VIRGINIA ELECTRIC AND POWER COMPANY
NORTH ANNA POWER STATION UNITS 1 AND 2
SURRY POWER STATION UNITS 1 AND 2
SUPPLEMENTAL RESPONSE TO NRC BULLETIN 2001-01 CIRCUMFERENTIAL
CRACKING OF REACTOR VESSEL HEAD PENETRATION NOZZLES
QUALIFIED VISUAL INSPECTIONS

**Evaluation to Support Qualified Visual Inspections
of the Reactor Vessel Heads
(Non-Proprietary)**

REQUEST FOR ADDITIONAL INFORMATION
ON THE NORTH ANNA UNITS 1 AND 2 & SURRY UNITS 1 AND 2
SUPPLEMENTAL RESPONSE TO NRC BULLETIN 2001-01
PLANT-SPECIFIC ANALYSIS IN SUPPORT OF A
QUALIFIED VISUAL EXAMINATION
TAC NUMBERS MB2641, MB2642, MB2886 & MB2668

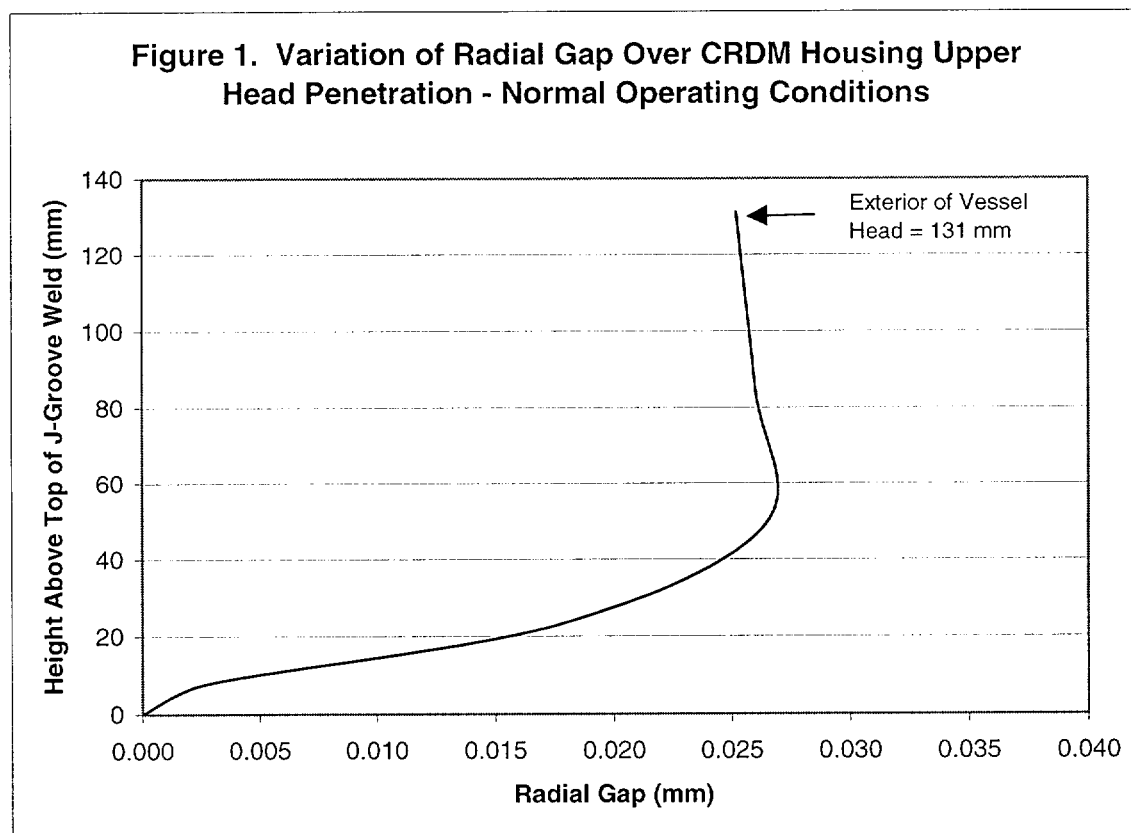
The two-dimensional model used to predict the final interference fit may not be adequate because the CRDM penetration was attached to the vessel head by the J-groove weld at the bottom of the interface only, and effects from this constraint are not modeled in the analysis. Provide results using an approach, which could estimate the variation of the interference fit along the length (axial) of the interface (e.g., using finite element method).

In References 3 and 4, the condition of the interference fit at normal operating conditions is determined for the North Anna and Surry units, respectively. The calculational approach used in these references consists of classical formulations for the effect of pressure and temperature on cylindrical (CRDM housing) and spherical (RV head) vessels. The conclusion of these evaluations is that for even the maximum specified diametrical interference fit, the interference would be relieved at normal operating conditions and a positive radial gap will exist.

In the original ASME design report for the reactor vessel for the Surry and North Anna units (References 1 and 2), the displacements and stresses at the CRDM vessel head penetration were evaluated using an axisymmetric finite element model. The J-groove weld is included in this model. The outline of the finite element model is provided in the attached Figure 9.4-5 from the North Anna stress report. A figure of the finite element mesh is provided in the attached Figure 9.4-3 from the Surry stress report. Additional figures of the finite element model are provided in the attached Figures F.9.4-8 and F.9.4-9 from the Surry stress report. For the purposes of this discussion, the structural models for both North Anna and Surry are identical.

As part of the analysis in the design report, the condition of the shrink fit is evaluated for the purpose of applying appropriate boundary conditions for the structural finite element model. The evaluation of the shrink fit is performed by determining the relative radial displacements of node pairs located on the CRDM housing and the ID of the vessel head penetration. The attached pages 9.4-36 through 9.4-39 from the Surry stress report (which includes Tables T.9.4-5 through T.9.4-8) provide a discussion and the results of the shrink fit evaluation. The locations of the node pairs used to assess the condition of the shrink fit are shown on the attached Figure 9.4-3. In assessing the condition of the shrink fit, the maximum specified shrink fit is evaluated (diametrical interference of 0.03 mm, 0.015 mm radially). For the normal steady state condition, it is determined that a positive radial

clearance exists for both Surry and North Anna along the length of the head penetration above the J-groove weld (Refer to attached Table T.9.4-7). Since the J-groove weld is modeled in the analysis, the radial clearance at the top of the weld will always equal zero. An additional, handwritten column has been added to Table T.9.4-7 to indicate the approximate distance from the top of the weld to the node pair locations. As shown in this table, the calculated radial gap reaches its maximum value approximately 49 mm above the J-groove weld, and maintains this approximate value to the outside of the vessel head penetration. The condition of the radial gap over the length of the vessel head penetration for normal operating conditions is shown graphically in Figure 1 below.

Based on the results of 1) manual calculations utilizing classical formulations for deflection of cylinders and spheres under internal pressure and temperature, and 2) detailed finite element analyses of the components, it is concluded that a radial gap will exist between the CRDM housing and the vessel upper head penetration. This gap will exist over the full length of the penetration above the J-groove weld. Based on the existence of this gap, leakage from CRDM penetrations (either through J-groove weld or the CRDM housing) can be identified by an external visual inspection of the reactor vessel upper head.
